SUBJECT: PHILIPPINE PRELIMINARY SITE INVESTIGATION REPORT

ACCIDENT ANALYSIS EVALUATION  
PRELIMINARY SITE INVESTIGATION REPORT  
PHILIPPINE NUCLEAR POWER PLANT

Philippine Nuclear Power Plant  
Unit No. 1

FIGURE 1 Cumulative Population Distribution

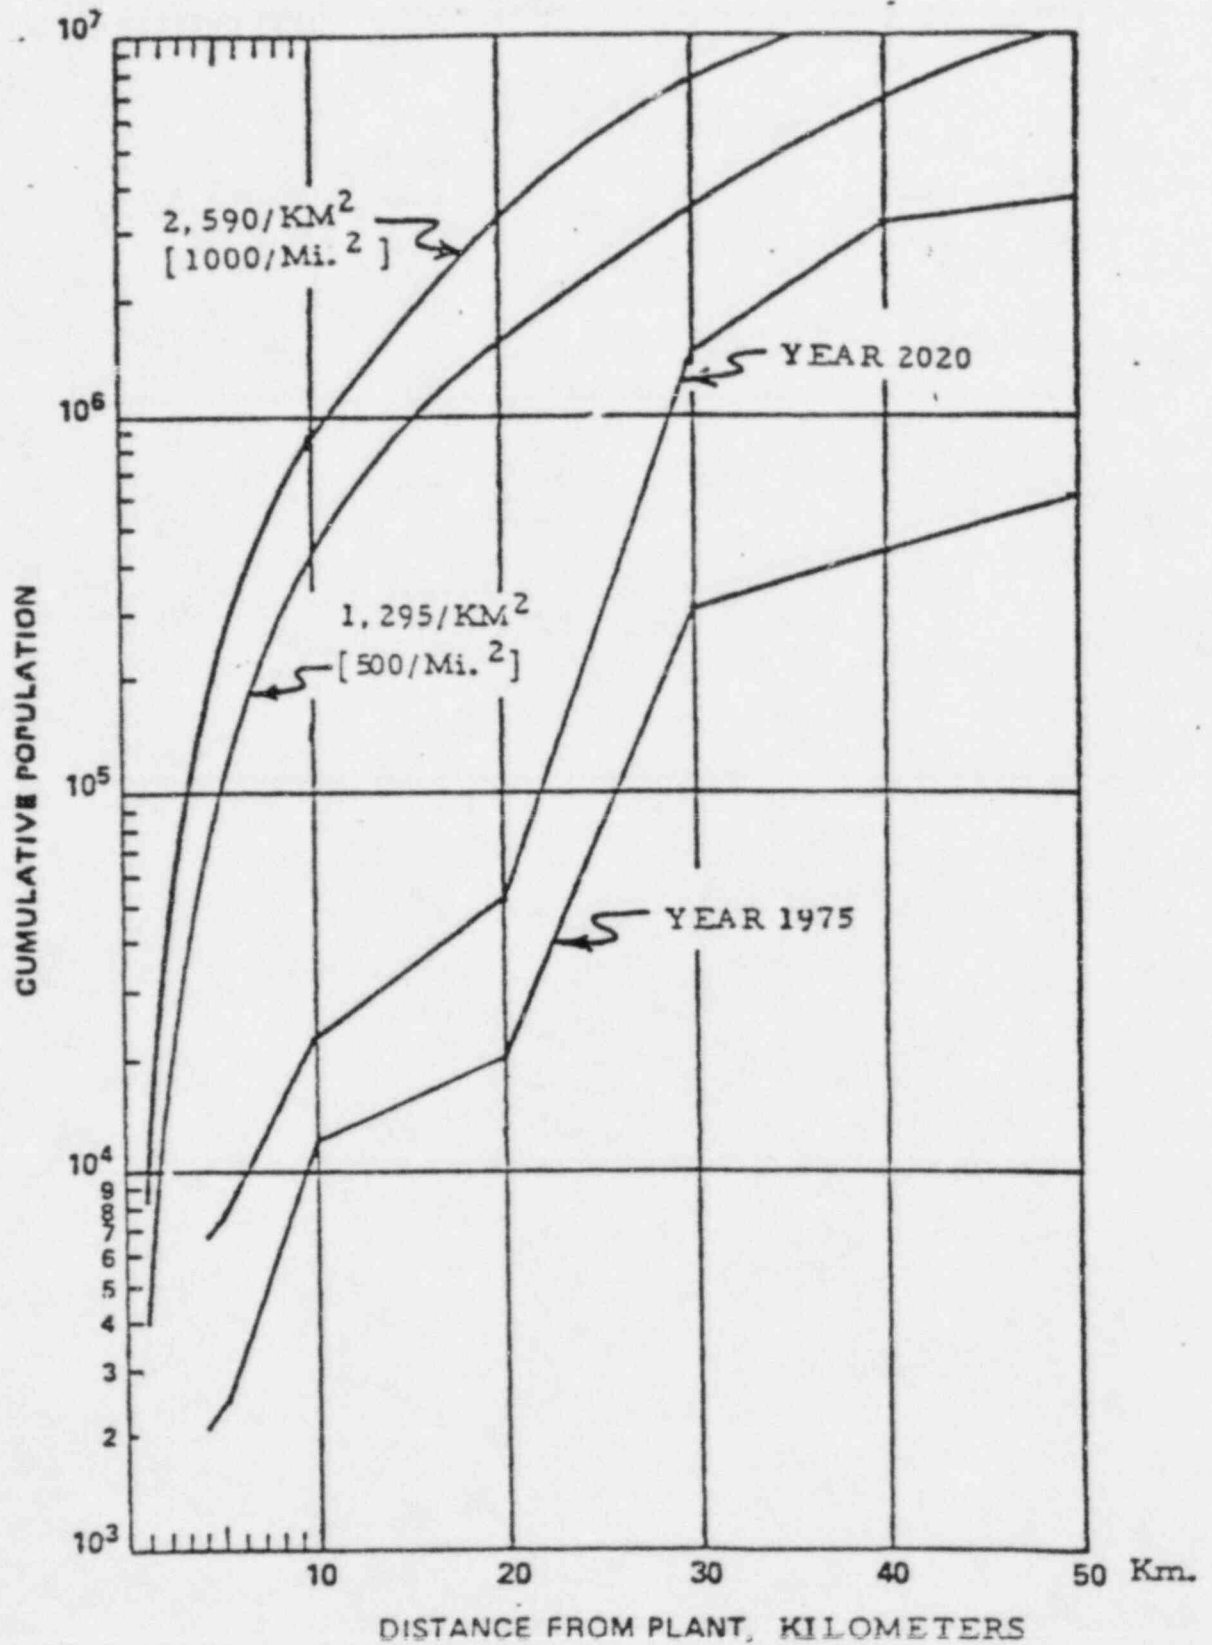
The National Power Corporation has supplied demographic data for the time period 1975-2020 out to a 50 Km radius. The population density at 50 Km (31 miles) for 1975 and 2020 is 87/Km<sup>2</sup> and 477/Km<sup>2</sup> respectively. Figure 1 shows the current and projected population at 50 Km radius to be 685,827 and 3,70,045 respectively. This figure indicates that the current and projected populations fall within the current NRC guideline values of 500 and 1000 people/mile<sup>2</sup> respectively. We see nothing unusual in the present and the projected population at this site which would require the review of alternate sites.
